PROPOSED DESIGN
FOR
BUILDING ON PLOT NO. 65 & 12 SHEET A27
NAPIER QUARTER

1609
23/8/18
With reference to his application dated 24th Jan. 1918 with plans for plot No. 65 & 12, A-27 Napier Quarter Mr: Valabdas Nanji sk is informed that the street level as well as the existing ground level must be shown on the Section. The ventilation is not sufficient for a four storied building; the area shown as " Godown" on the ground floor and kitchen on the upper floors must be left open to sky. It must be shown how the partition walls are to be carried on the different floors.

The Street level as well as the existing ground level must
be shown on the section. The ventilation is not
sufficient for a four storied building, the
area shown as "godown" on the front floor & kitchen
on the upper floors must be left open to sky.
It must be shown how the partition walls are
to be carried on the different floors.

GROUND FLOOR PLAN

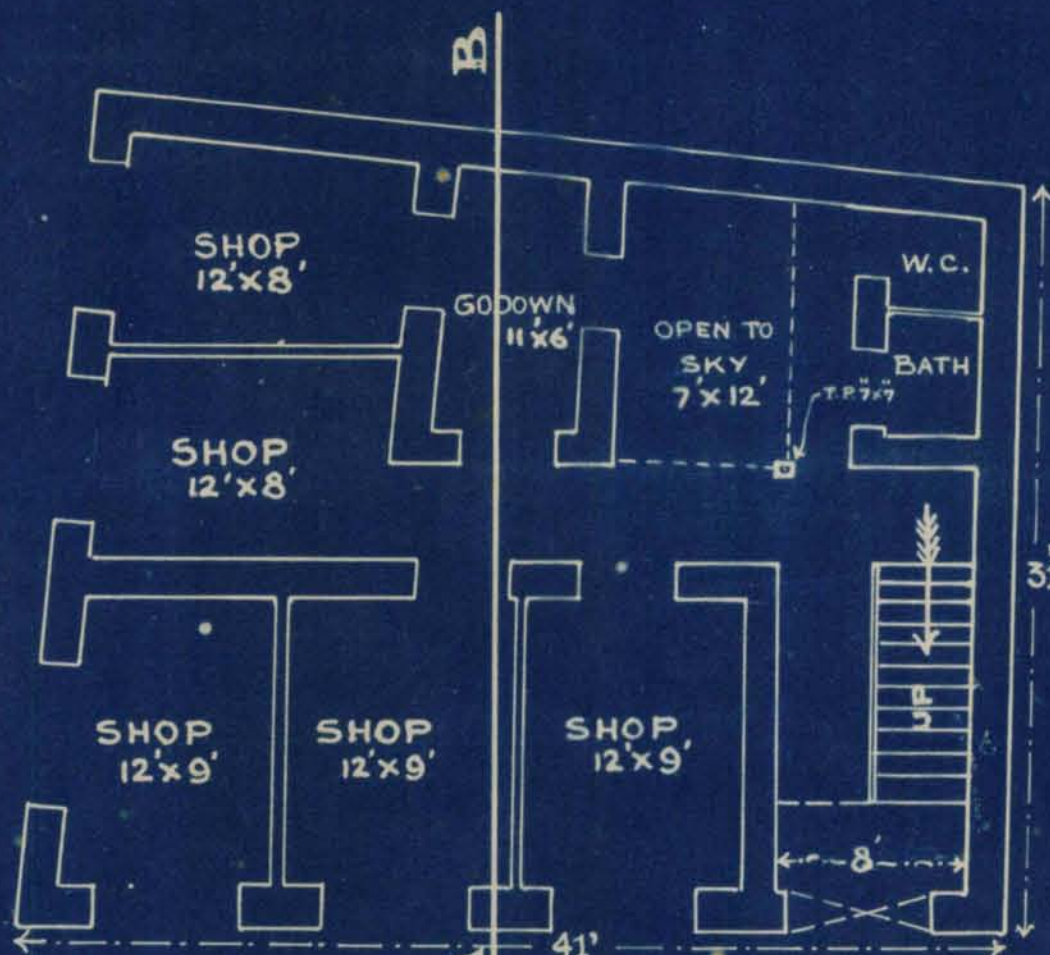
With reference to his application dated 14th inst. with plans for plot No. 65 & 12, A-27 Napier Quarter on behalf of Valabdas Nanji Mr: D.H. Daruwala is informed that the plan must be properly amended so as to avoid disputes afterwards. The wall to be deleted must be removed from the plan, the ~~open~~ space correctly dimensioned and the section made to agree with the plan.

(2) The area shown as garden on the ground floor and kitchen on the upper floors will be left open to sky.

(3) The partition wall will be carried one over the other from the ground to the upper floor and will be supported on wooden Timbers 6" x 6" from floor to floor.
